105 Carrington Road, Box Hill

Design Review

onemilegrid has been engaged to provide traffic engineering input and design advice in relation to the car parking layout for the residential development at 105 Carrington Road, Box Hill.

Figure 1 Cross-Sections

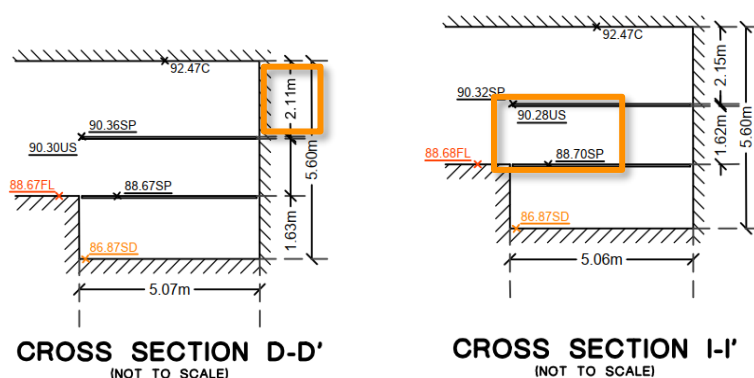
In relation to vehicle heights, it is shown in Cross Section D-D that the minimum height clearance in the upper stackers (platform to ceiling) is 2.11m. Similarly, the levels in Cross Section I-I show the minimum height clearance in the lower stackers (platform to underside of platform) is 1.58m (noting the dimension shown is platform to platform).

Design Standard 4: Mechanical parking of Clause 52.06-9 of the Planning Scheme requires that 25% of mechanical car parking can accommodate a vehicle height of at least 1.8 metres. Based on the above cross-sections, the upper platform in each stacker system (i.e. 50%) can accommodate vehicles of in excess of 1.8 metres (up to 2.1m), in excess of the requirements of the Planning Scheme.

The lower spaces can accommodate vehicles in excess of 1.5 metres. According to the Australian/New Zealand Standard for Parking facilities, Part 1: Off-street car parking (AS/NZS 2890.1:2004), "The height of all passenger cars and station wagons is below 1.5 metres.", therefore the height clearance in the lower stacker spaces is considered to be appropriate.

Project Number 180708	Drawing Number SPA400	Revision A
--------------------------	--------------------------	---------------

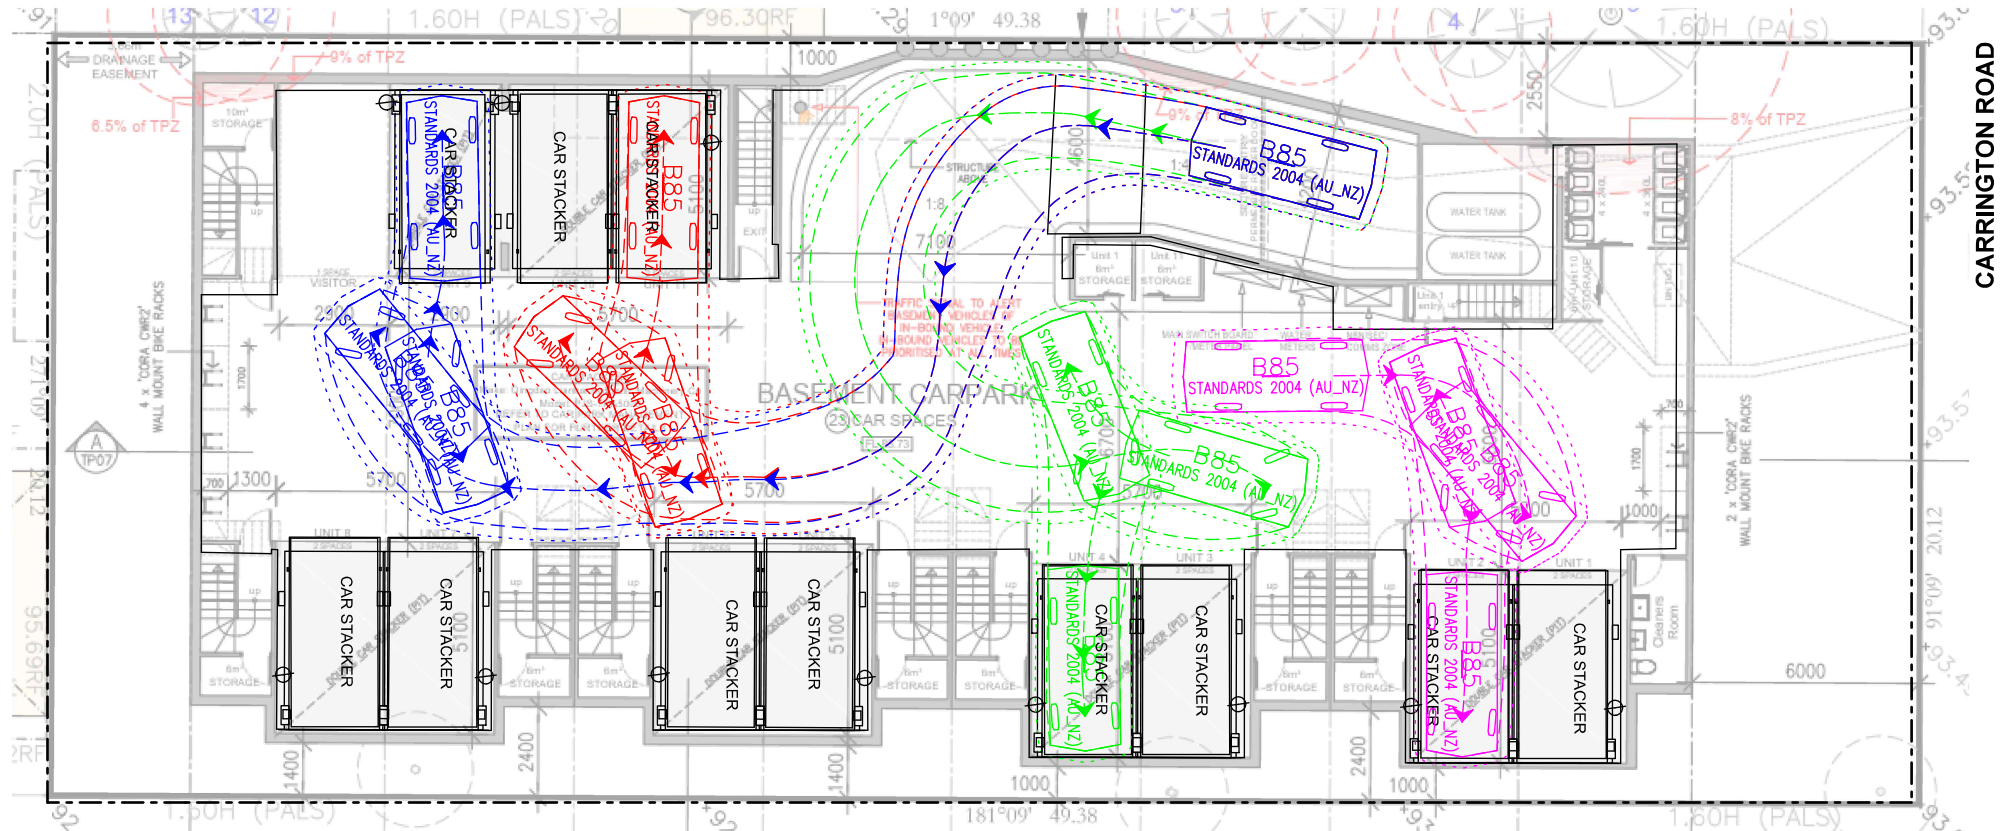
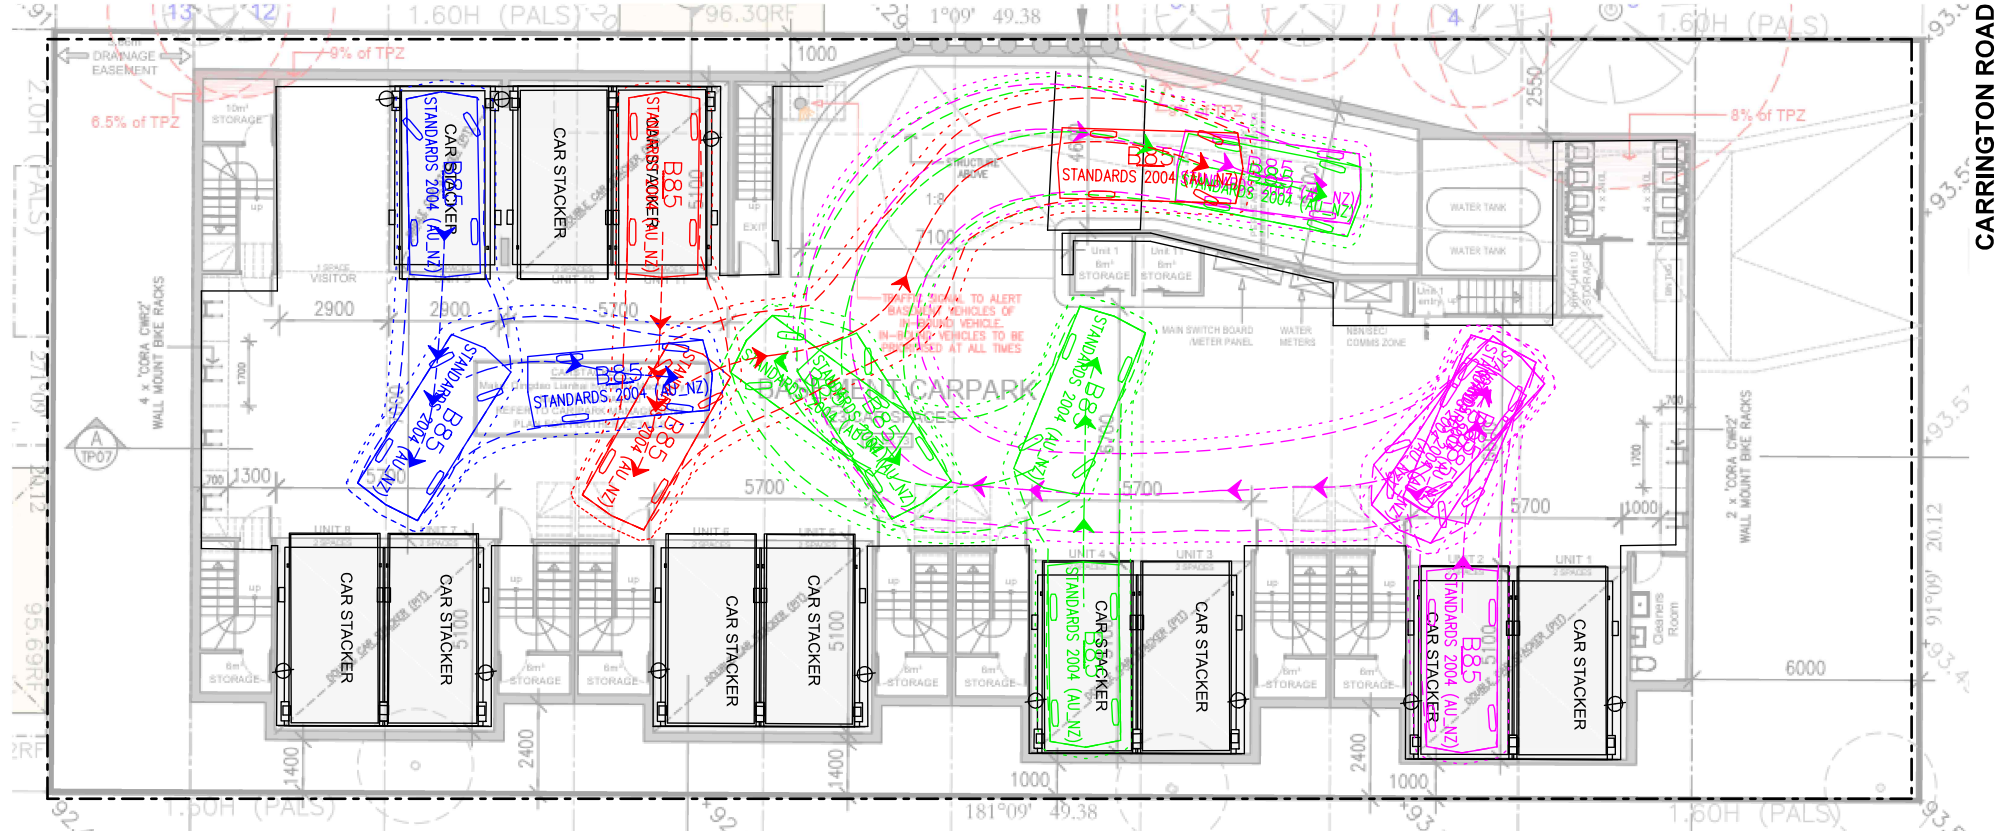
Assess the access into the existing car stackers (based on the above survey plans) via the provision of swept path diagrams of the B85 design vehicle into the proposed car stacker space. The plans are to show the details and dimensions of the car stacker installed i.e column locations and railings etc

The attached swept path diagrams (SPA4001, SPA401 and SPA402) have been prepared to demonstrate the accessibility of the stacker units for a B85 design vehicle, based on the survey plans and the detailed dimensional specifications of the stacker units, which confirms the surveyed information.

It is demonstrated that even for the B99 vehicles, at most a single corrective movement is required on entry or exit from the stacker spaces. It is noted that the full 300mm clearance envelopes cannot be maintained through the full movement into or out of the stacker unit, though this is typical for a stacker system, where structural elements of the stacker unit restrict the available clearance. Further, it should be noted that a typical basement car park designed to the Australian Standard minimum requirements (with a 2.4m wide parking bay and columns located adjacent) will not allow for the retention of the full clearance envelopes on both sides of a vehicle swept path, even for a B85 vehicle. Furthermore, in relation to the B99 vehicle, it is noted that these will be required to be positioned on the upper platform space (refer to the commentary below), which are not impacted by the stacker columns below.
